**From:** [General](#)  
**To:** [Planning](#)  
**Subject:** FW: planning application nym/2018/0177/fl  
**Date:** 13 June 2018 11:04:10

From: NEIL PURVES  
Sent: 13 June 2018 10:57  
To: General  
Subject: planning application nym/2018/0177/fl

PROPOSED PLANS / ELEVATIONS / SECTION  
1:100 & 1:50 SCALE AT A1 SIZE  
P&N Design, Chartered Architectural Technologists  
Unit 34b, Welton Business Park, Wiske Avenue,  
Brough, East Yorkshire, HU15 1ZQ  
Client: GHILL WOOD DEVELOPMENTS Ltd Date: 14-3-18  
Project: Proposed tea hut Scale: 1:100 & 1:50  
Site: The Quarter deck, Robin Hood Bay Dwg No. 2723-1A

Section

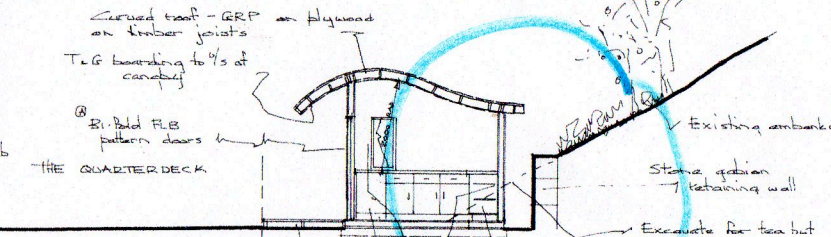
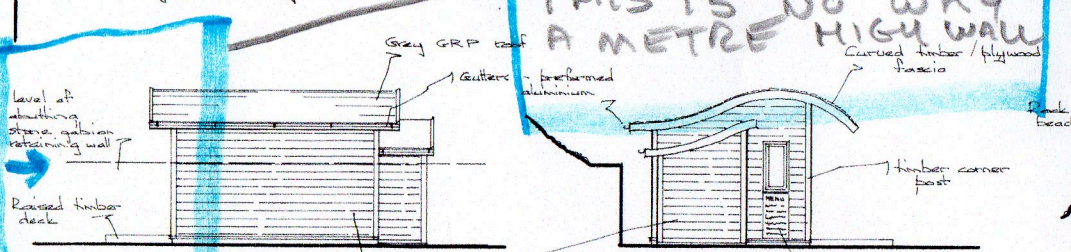
For the attention off Chris France,Mark Hill Hilary Saunders,Re planning application nym/2018/0177/fl. I have some concerns that the planning application shows different heights for the proposed retaining gabion basket wall.I feel this is relevant as the Scarborough coastal area engineer will have looked at the plans showing a small wall at 1 metre and not been worried when in fact the height could be much more and much more excavation and a taller wall would be actually be built.The coastal engineer has asked for the digging to be kept at a minimum .The attachments from the planning application show 1.A metre high wall.2.Shows 2x 60cm high baskets so 1.2metres and 3.The plans show 3 baskets and to scale so a 1.8 metres high wall.The distance has actually been measured from the edge of the quarterdeck back to where the far edge of the wall would be at approx 6 metres back(1.45m frontage.hut3.05 metres.gap at rear of hut.0.5metre.Gabion basket width 1 metre) and the actual height gog out comes out at over 2 metres .As the plan states the existing embankment is to stay and no removal of trees(there are small trees and bushes on the bank)and as the plans appear to show different heights i would ask that you look at the plans perhaps measure the slope and retaining height needed? And if wrong please take action.It may well be that the plans are actually to take away more cliff and re profiling of the slope to make the 1metre fit but if this is so i believe as there are trees,Bushes and land drains on the coastal slope in a consevation area that it should be on the plans if so. Neil Purves,Willow dene,Church lane,Fylingthorpe,North Yorkshire,yo224pn.

THIS IS NO WAY A METRE HIGH WALL
